SERVICE BULLETIN

N° **139-524**

ATA 25 - LIFERAFT RESERVOIR ASSEMBLY ALIGNMENT LABEL POSITIONING

DART AEROSPACE SERVICE BULLETIN SB2018-09 REV. E |
LIFERAFT RESERVOIR ASSEMBLY ALIGNMENT LABEL
POSITIONING FOR AW139 EMERGENCY FLOAT
KITS W/ LIFERAFTS

Figure 2: P/N 3G2560V01251/650.4703 Left Hand Reservoir Label Position (Looking Down)

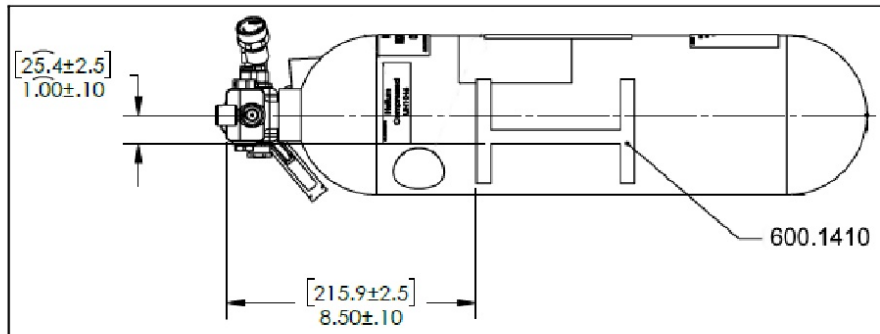
3. Verify the P/N 600.1410 Alignment Label is installed per Figure 2 (LH Side) or Figure 3 (RH Side).
4. If the label is correctly installed, record compliance onto the component log card. If the label is misaligned, proceed to Step 5).

5. Carefully remove the alignment label starting from a corner edge. Take care not to cause damage to the outer layer of the cylinder.
6. Remove any excess adhesive from the surface of the cylinder. Any commercially available non-abrasive adhesive removal solution is allowable.
7. Clean and dry the surface prior to installation of new alignment label.

8. Remove the adhesive backing from the Alignment Label and install on the cylinder per Figure 2 or Figure 3. Apply pressure to the labels and remove any air bubbles.
